GEN-2016-030 and GEN-2017-232 Modification Request Impact Study

Revision R1 October 27, 2025

Submitted to
Southwest Power Pool

Figure 2-2: GEN-2016-030 and GEN-2017-232 Single Line Diagram (Modification Configuration)

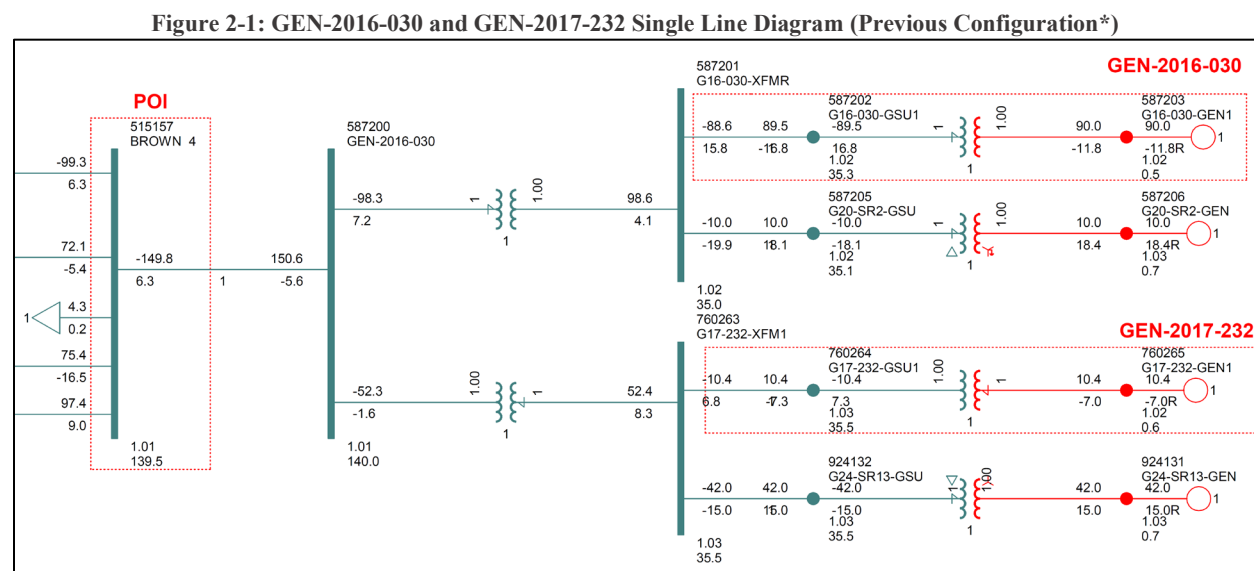
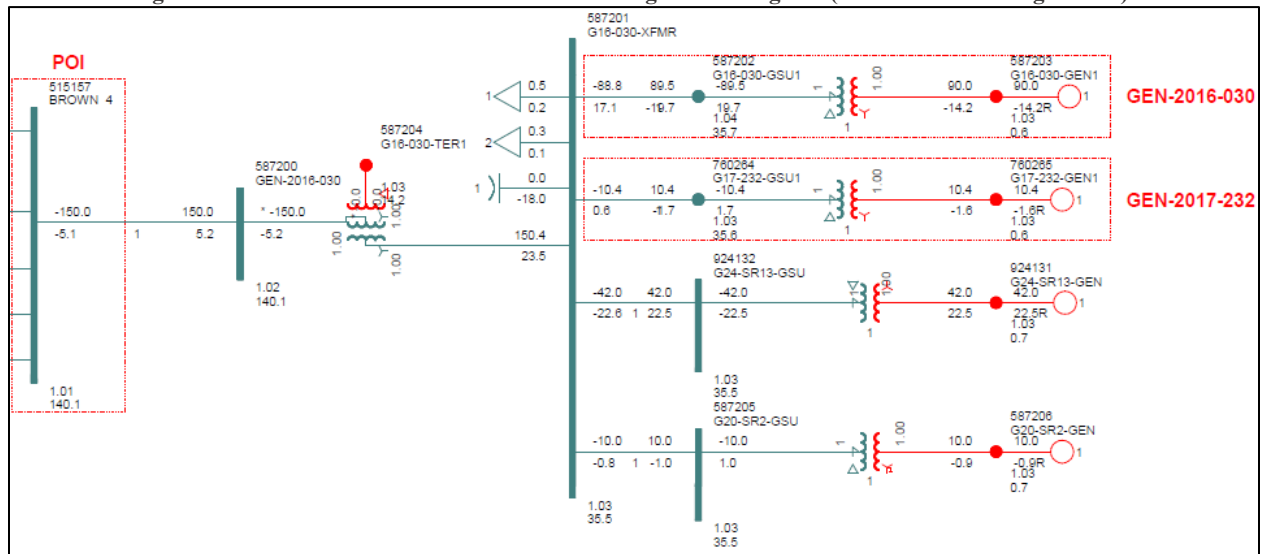
Figure 2-1 shows the power flow model single line diagram for the GEN-2016-030 and GEN-2017-232 configurations as modeled in the DISIS-2021-001 25SP stability model with the GEN-2020-SR2 and GEN-2024-SR13 surplus projects included.

This Study has been requested to evaluate the modification of GEN-2016-030 to change the configuration to 26 x Sungrow SG4400 solar inverters operating at 3.9327 MW for a total assumed dispatch of 102.25 MW. It is also modifying GEN-2017-232 to a configuration of 13 x Sungrow SG4400 solar inverters operating at 4.0925 MW for a total assumed dispatch of 53.2 MW. The inverters for both projects are rated at 4.4 MVA, thus the total generating capabilities exceed their Generator Interconnection Agreement (GIA)

In addition, the modification request included changes to the reactive power devices, auxiliary loads, collection system, generator step-up transformers, main substation transformer, and generation interconnection line for each project. Figure 2-2 shows the power flow model single line diagram for the GEN-2016-030 and GEN-2017-232 modifications with the GEN-2020-SR2 and GEN-2024-SR13 surplus projects included. The existing and modified configurations for GEN-2016-030 and GEN-2017-232 are shown in Table 2-1 below.

Interconnection Service amounts. The injection amounts must be limited to 100 MW and 52.2 MW respectively at the POI as listed in Appendix A of each project's GIA. As a result, the customer must ensure that the amount of power injected at the POI does not exceed the Interconnection Service amount. The requested modification includes the use of a Power Plant Controller (PPC) to limit the total power injected into the POI.

Figure 4-1: GEN-2016-030 and GEN-2017-232 Single Line Diagram (Previous Configuration)

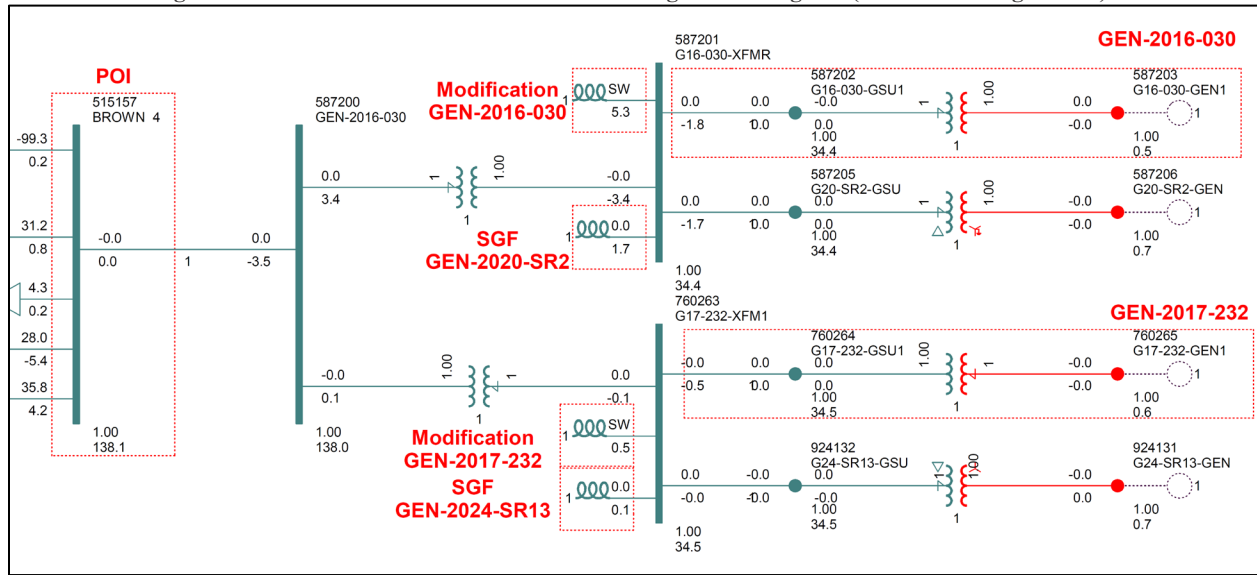
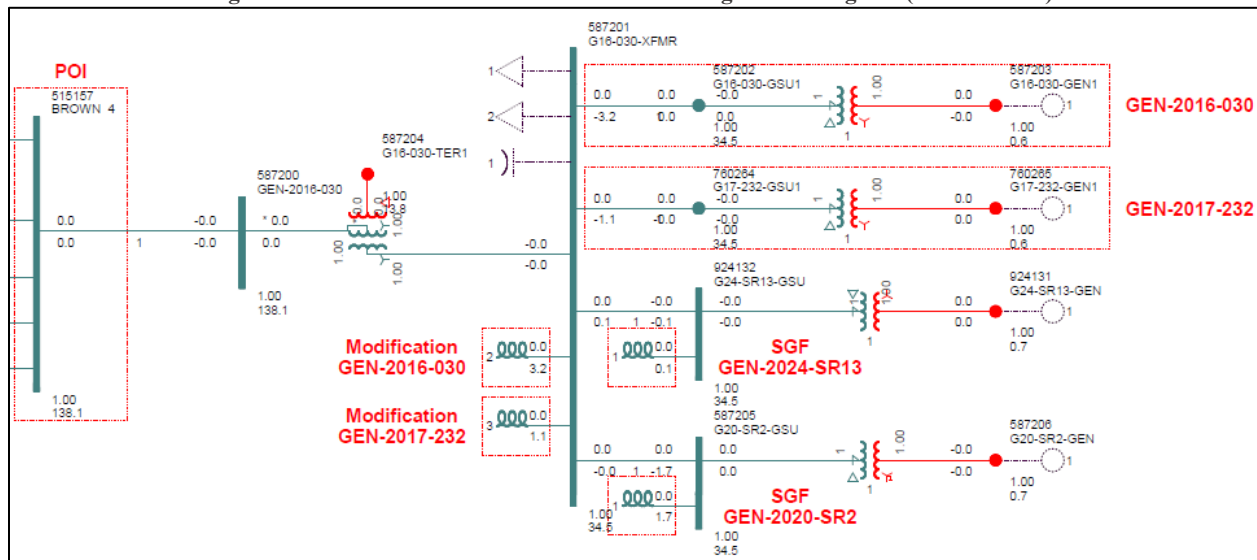
The results from the analysis showed that the GEN-2016-030 and GEN-2017-232 projects needed approximately 3.2 MVar and 1.1 MVar respectively of compensation at their collector substations to reduce the MVar injection at the POI to zero with the SGF reactors in place. This is a decrease for GEN-2016-030 from the 5.3 MVar found in the previous configuration, and an increase for GEN-2017-232 from the 0.5 MVar calculated. The final shunt reactor requirements are shown in Table 4-1. Figure 4-1 illustrates the shunt reactor size needed to reduce the POI MVar to approximately zero with the previous configuration. Figure 4-2 illustrates the shunt reactor size needed to reduce the POI MVar to approximately zero with the updated topology.

The information gathered from the reactive power analysis is provided as information to the Interconnection Customer and Transmission Owner (TO) and/or Transmission Operator (TOP). The applicable reactive power requirements will be further reviewed by the TO and/or TOP.
